IREDELL C[illegible]Y HEALTH DEPARTMENT

IMPROVEMENT PERMIT / AUTHORIZATION TO CONSTRUCT / OPERATION PERMIT / EXISTING SYSTEM INSPECTION

PERMIT# 12502 PIN# 4639 61 5556.122 (4639 70 5485) DATE 11/14/06

SUBDIVISION BAYCROSSING BLOCK / SECTION [illegible] LOT 122 LOT AREA 1.93AC SITE CLASS. PS DESIGN FLOW 480GPD L.T.A.R. .3600/Ft

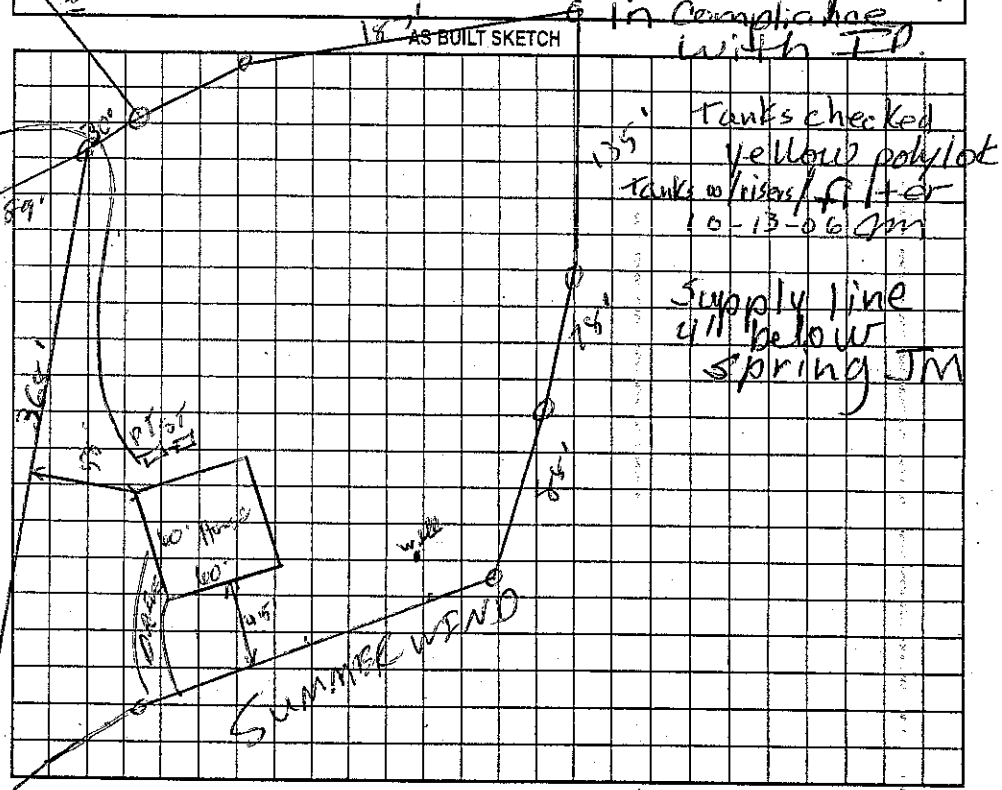
The proposed / existing Stairway to Deck addition does not appear to impact the existing septic system.
**NOTE: Must keep footer at least 5Ft from tanks Maria Dotson REHS
Date: 11/21/2011
ICHD-Environmental Health Division

Comments:/Conditions: CROSS SPRING PROPERLY WITH SUPPLY LINE. CONTACT HEALTH DEPARTMENT BEFORE INSTALLATION

Reviewed plans, in Compliance with I.P.

Tanks checked yellow poly lot Tanks no risers/filter 10-13-06 JM

Supply line all below spring JM
